CERTIFICATE OF APPROPRIATENESS

Property: 610 Marshall Street, Lot 1, Tract 5A-1, Block 14, Montrose Subdivision. The property includes a 2,034 square foot house with wood deck at rear and a frame detached garage, situated on a 6,000 square foot (50' x 120') interior lot.

Proposal: Alteration – Addition (already built, multiple citations for working without a permit) Applicant seeking approval for completed addition at the side/rear of the historic residence.

EAST ELEVATION – SIDE

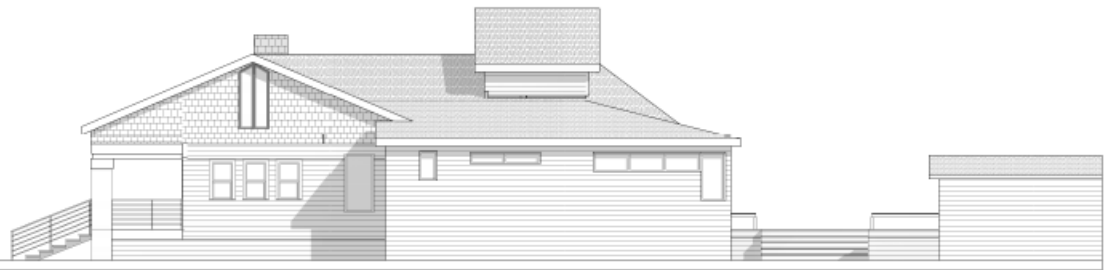
<i>Proposed addition removed historic fabric, specifically the rear corner of original building and historic windows (East elevation). . See HAR photo c. 2013.</i> |

<i>Proposed addition removed historic fabric, specifically historic windows on East Elevation. See HAR photo c. 2013.</i> |

Staff recommends an issuance of a COR. Applicant must restore East elevation light pattern to match original window pattern.

PROPOSED DEMOLITION PLAN
(ALREADY COMPLETE, ORIGINAL BUILDING DEMOLISHED IN RED)

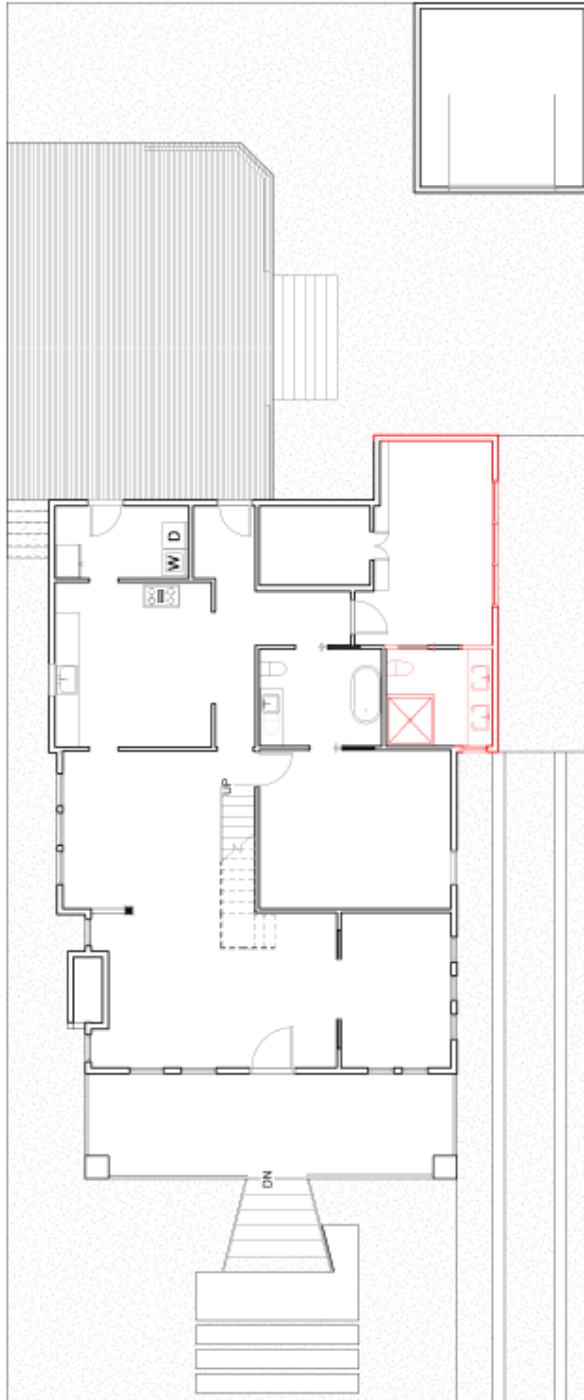
<i>Proposed addition removed historic fabric.</i> |
